COMPOSITE PLAN (FOR REFERENCE ONLY)

DRAWING TITLE
PROPOSED DEMOLITION PLAN

DRAWING TITLE
EXISTING SITE PLAN (FOR REFER. ONLY)

DRAWING TITLE
PROPOSED DIMENSIONED SITE PLAN

DRAWING TITLE
EXIST. FL. PLAN & ELEVATIONS VILLA#1 (FOR REF. ONLY)

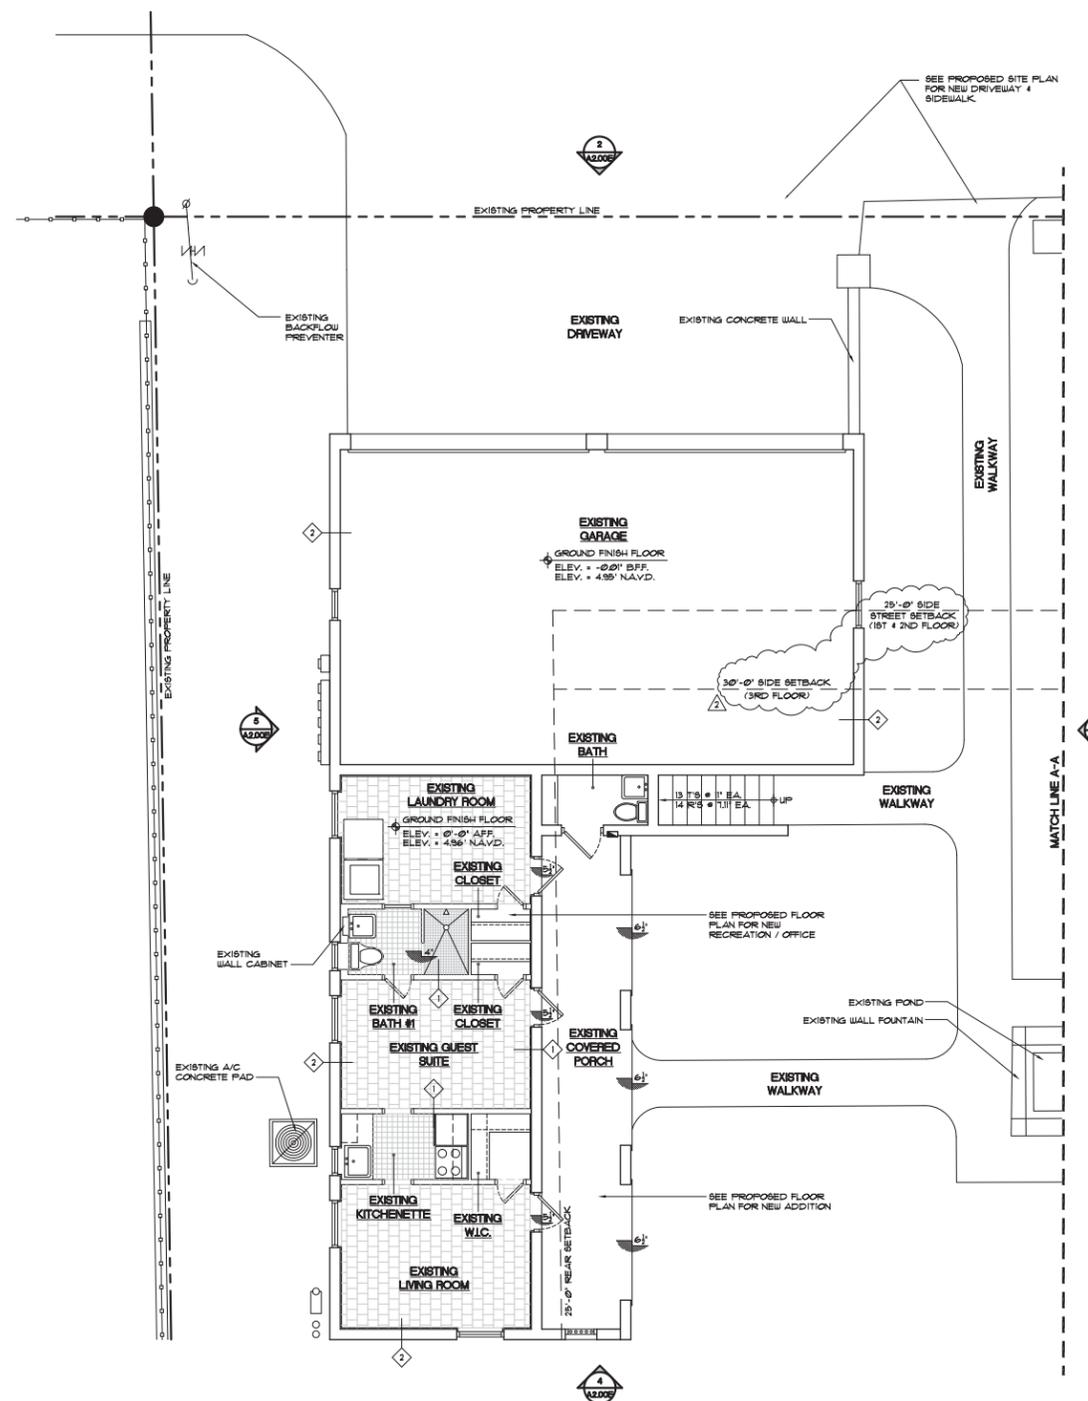
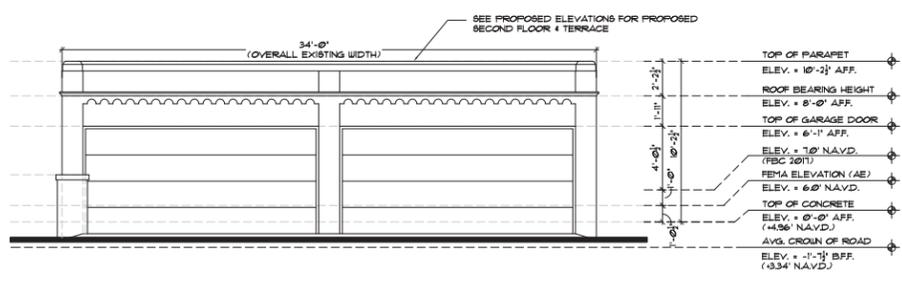
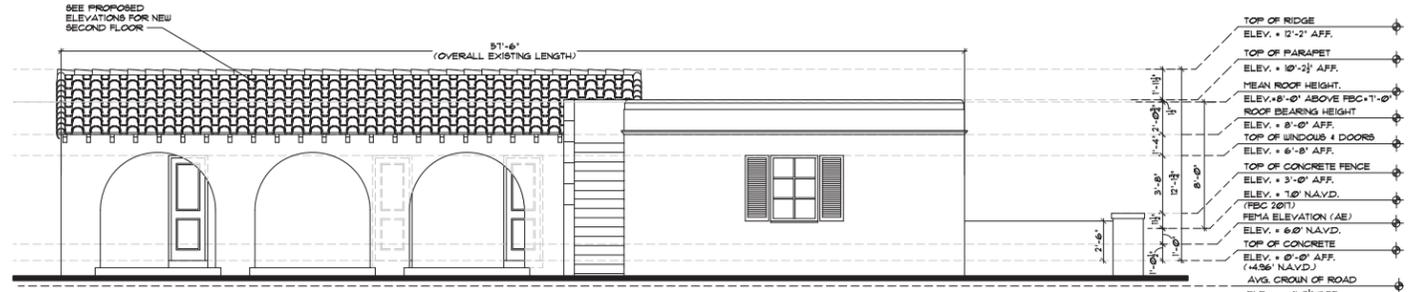
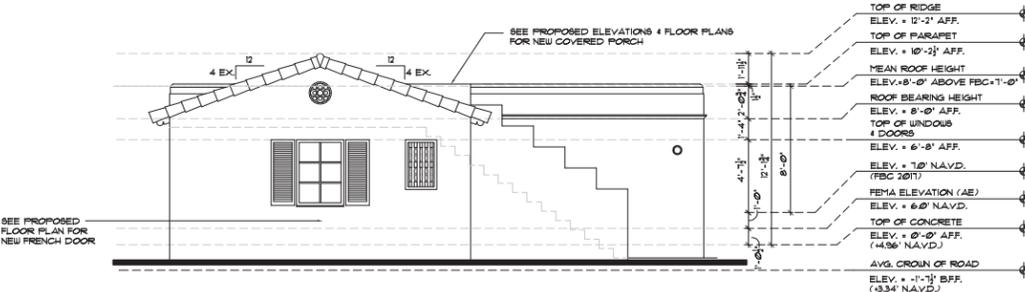
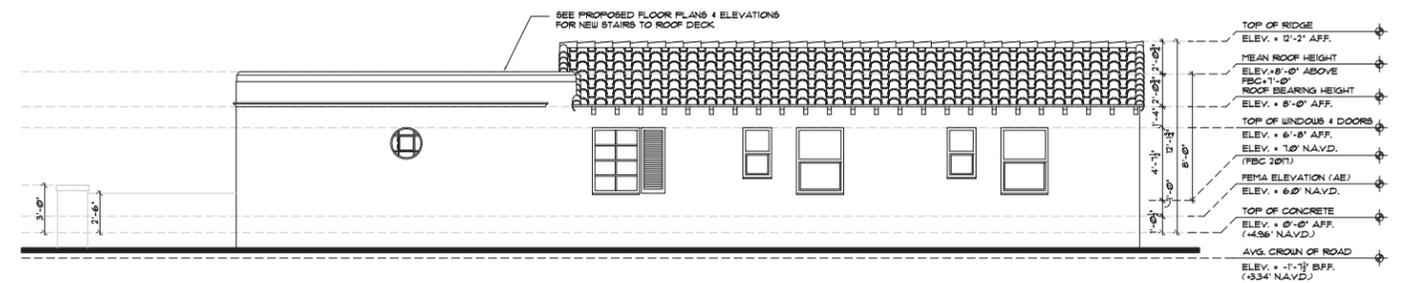
CLIENT APPROVAL
 REVISIONS
 1. REVISED 6.10.19 AS PER CITY COMMENTS:
 1. PROVIDED EXISTING SQUARE FOOTAGE
 2. PROVIDED FEMA ELEVATIONS & NEW PAGE LAYOUTS.
 2. REVISED 9.16.19 AS PER CITY COMMENTS:
 1. UPDATED SETBACKS.
